Control Rod Insertion
Following a Cold Leg
LBLOCA, D. C. Cook,
Units 1 and 2

I&M RESPONSES TO NRC
QUESTIONS FROM MAY 6, 1999 PUBLIC MEETING

INDEPENDENT REVIEW OF CONTROL ROD INSERTION FOLLOWING A COLD LEG
LBLOCA, D. C. COOK, UNITS 1 AND 2

FIGURE 1.
 SCHEMATIC OF CONTROL
 ROD DRIVELINE

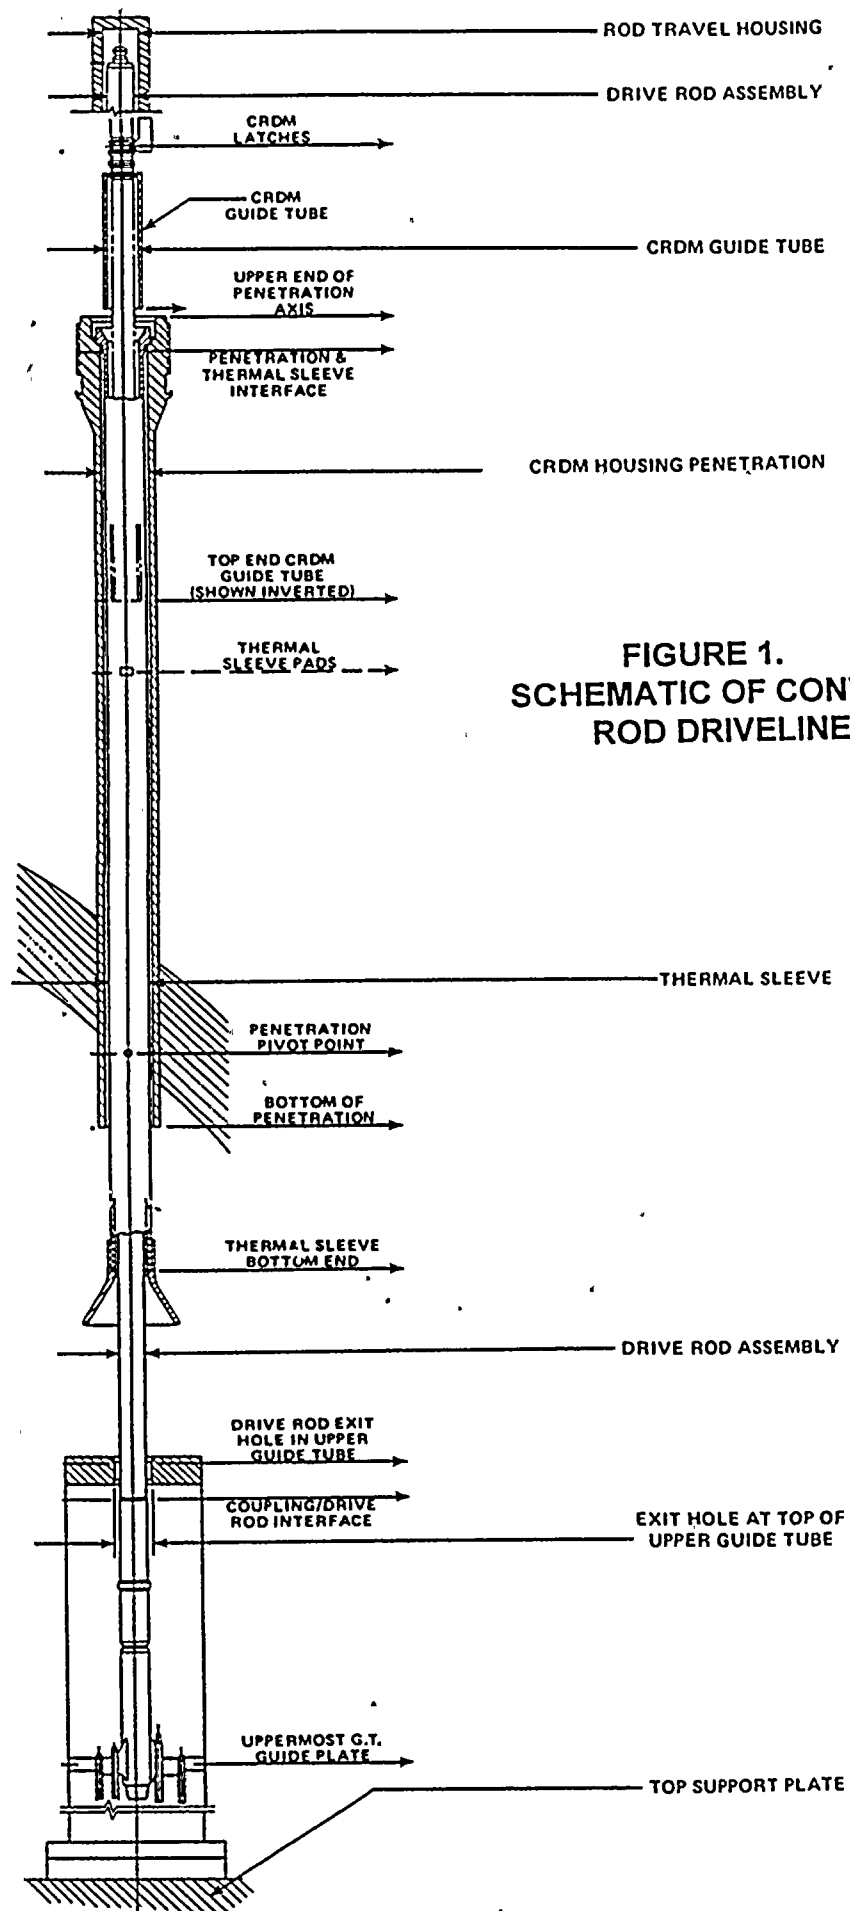
1. Question: Would the movement of the internals packages within the vessel during the blowdown, given allowable clearances and tolerances, cause a distortion of the control rod driveline alignment that could impact the ability of the rods to insert?

Response: Lateral displacement of the reactor vessel upper internals with respect to the reactor vessel, resulting from LBLOCA and seismic forces, could theoretically affect the ability to insert the control rods through binding of the control rod drivelines. This might occur as the drive line passes through the thermal sleeve on the reactor vessel head and subsequently through the upper section of guide tube attached to the upper internals support assembly. As discussed below, this is not a concern with the Westinghouse reactor design since clearances have been provided in the components adjacent to the driveline to prevent such an occurrence. Lateral displacement of the lower internals package does not directly affect the driveline alignment and is not a concern.

The maximum lateral displacement of the upper internals package with respect to the vessel is limited by the gap between the upper support assembly flange and the reactor vessel, which for D. C. Cook Unit 1 at the end of blowdown (30 to 60 seconds into the LBLOCA transient) is 0.202 inches. The gap width for Unit 2 is less with a value of 0.163 inches. However, it is noted that the upper internals package does not experience significant lateral hydraulic forces during a cold leg break and could only be displaced by motion of the lower internals package which is transmitted to the upper package. This could occur through the coupling provided by the head and vessel alignment pins once the gaps surrounding the pins have closed. The lateral displacement of the lower internals is limited by contact at the vessel outlet nozzles as well as at the vessel support ledge. Thus, a number of factors indicate that the upper internals package would move less than the full gap width during a cold leg LOCA plus seismic event. However, as a conservative upper bound, the limiting vessel to upper support plate gap width at normal operating temperature is assumed.

With the release of the Control Rod Drive Mechanism (CRDM) grippers following a reactor trip signal, the CRDM drive rod has significant radial gaps to accommodate lateral misalignments at the vessel head penetration and lower end of the thermal sleeve. In this area, the driveline is within the thermal sleeve which extends from the bottom of the CRDM housing to within a few inches of the top of the guide tube, Figure 1. There is a radial gap between the drive rod and the thermal sleeve within which the drive rod is free to move. In addition, the thermal sleeve is free to rotate at its upper end, such that at the bottom end there is radial gap between the I.D. of the

vessel head penetration and the O. D. of the thermal sleeve. This radial gap is available to accommodate lateral displacement of the upper internals package. Thus, the CRDM drive rod has two radial gaps available at the bottom end of the thermal sleeve to accommodate upper package displacement. The calculated bounding value for upper internals displacement inches can be accommodated by this allowable lateral displacement. Therefore, the occurrence of significant frictional forces which would retard control rod insertion will be precluded.
